MEETING OF THE HISTORIC DISTRICT COMMISSION

May 20, 2020

AGENDA

Previously Approved Design 04-12-2019 111 MAPLEWOOD AVE PORTSMOUTH, NH

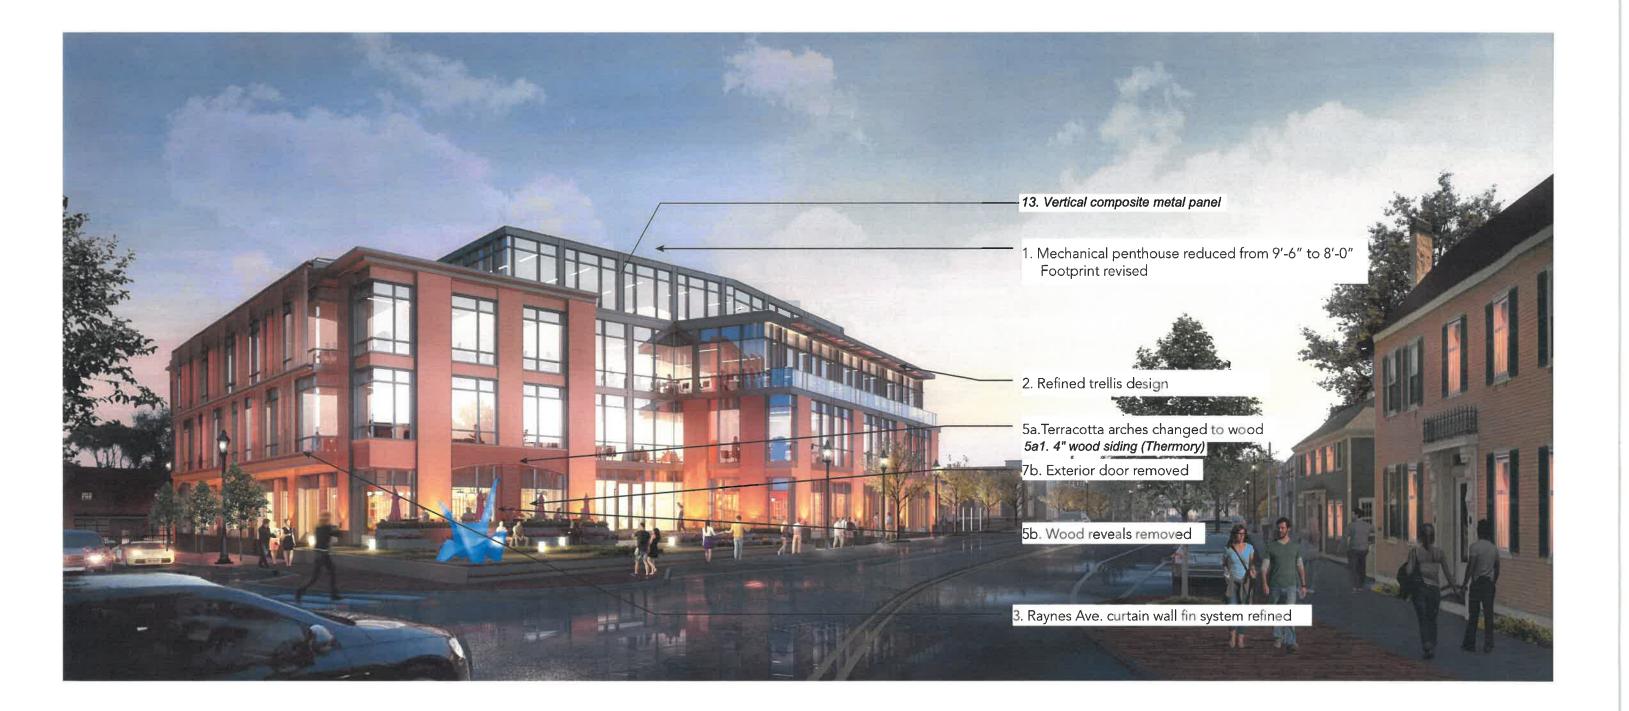
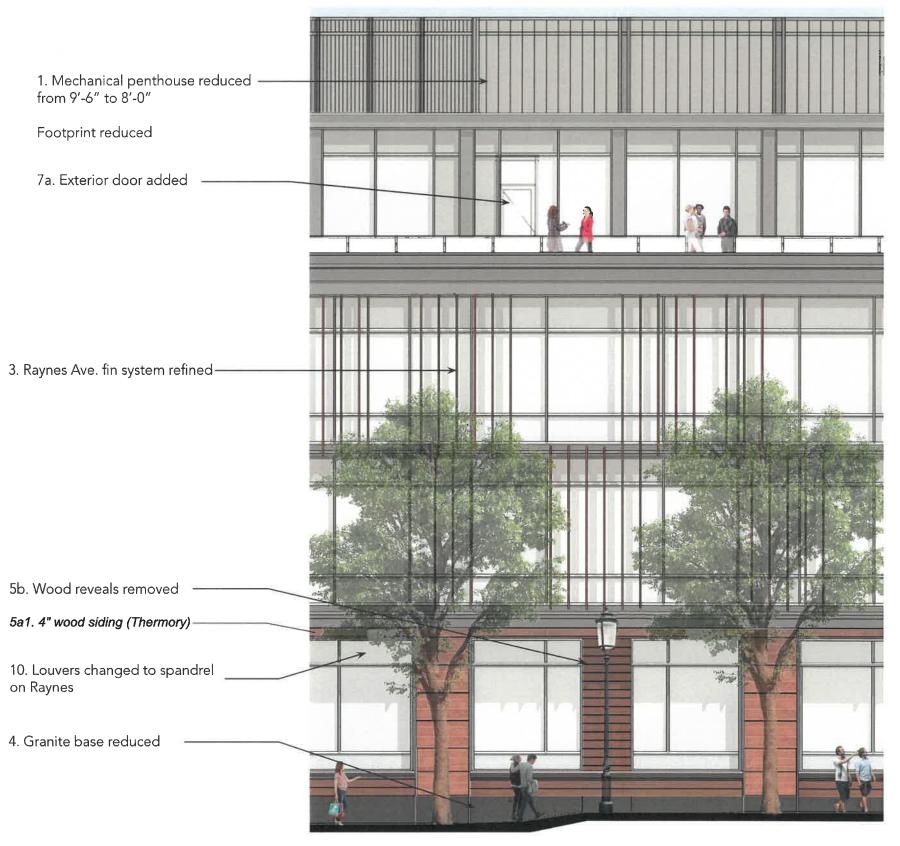
13. Vertical composite metal panel-7a. Exterior doors added 18. Cornice height clarified, 3'-1" tall 12. Terra cotta profile reduced to 16" from 18"-5b. Wood reveals removed

SETBACKS + BUILDING HEIGHTS 111 MAPLEWOOD AVE PORTSMOUTH, NH

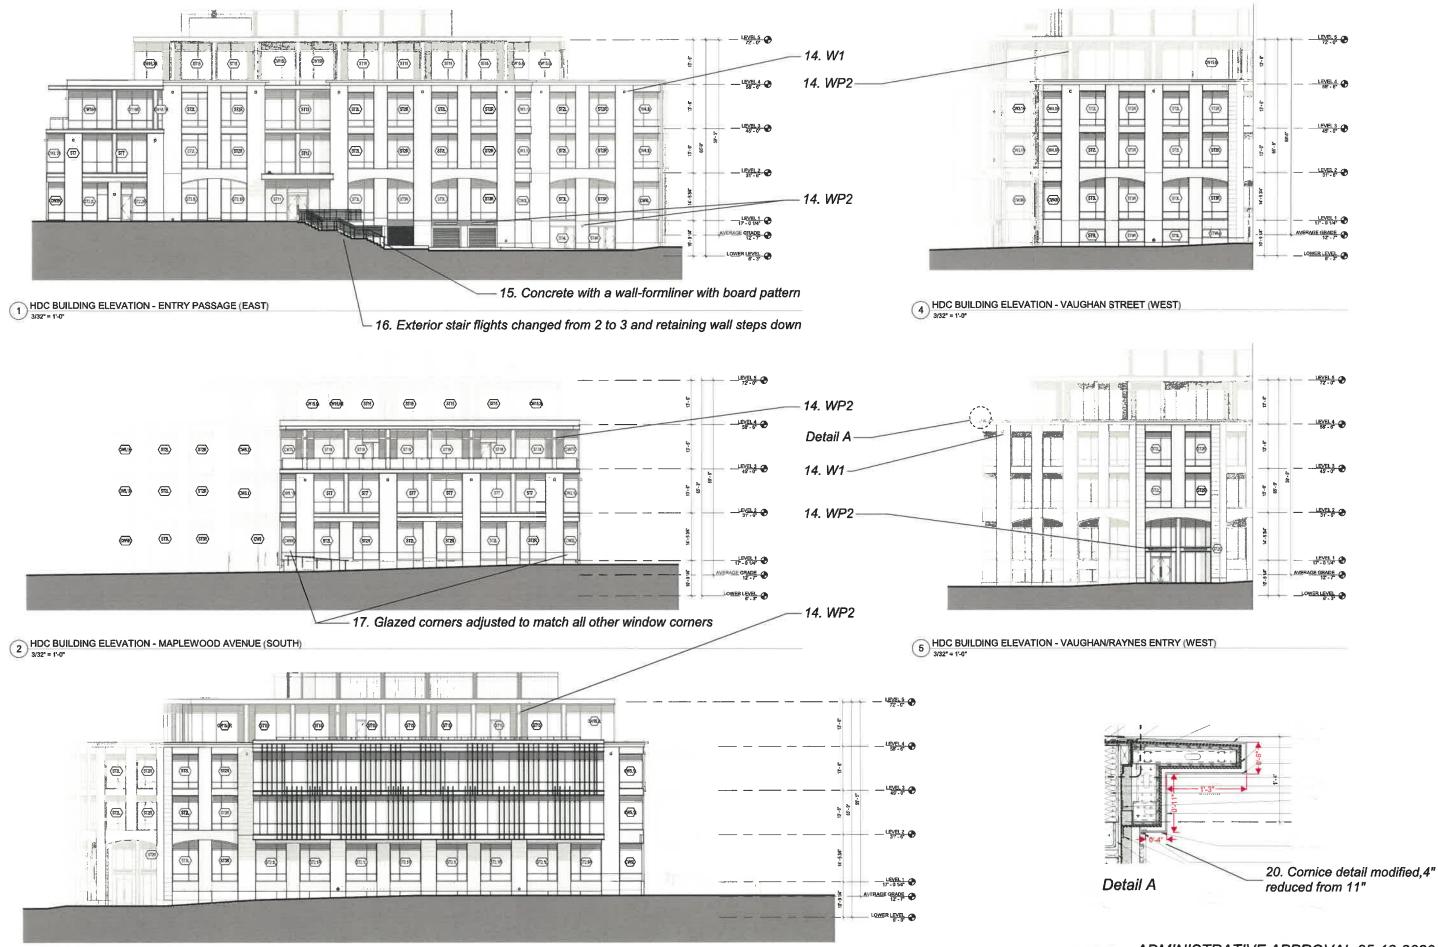
B. "Setback Key Plan – Fourth Floor" indicates the fourth floor structure will be setback 50' from the edge of parking spaces on Raynes, Maplewood, and Vaughan R.O.Ws. Pg. 21 of the January 8, 2020 HDC approval indicates the fourth floor structure is setback 50' from edge of curb on the respective streets.

Response: The 50' setbacks shown on sheet LS.04 measure from the travel lane curb line. We understand from the Owner's Attorney, based on a letter sent to Juliet Walker dated February 14, 2019 (Appendix A), that the travel lane curb line is to be used for this setback, not the parking curb line. Pg. 21 of the January 8, 2020 HDC approval indicates "back from curb", but is unclear which curb line is referenced. Approved civil plans are based on the travel lane curb line for these setbacks. Note 8a. Diagram on page 21 of the January 8, 2020 HDC Submittal will be updated.
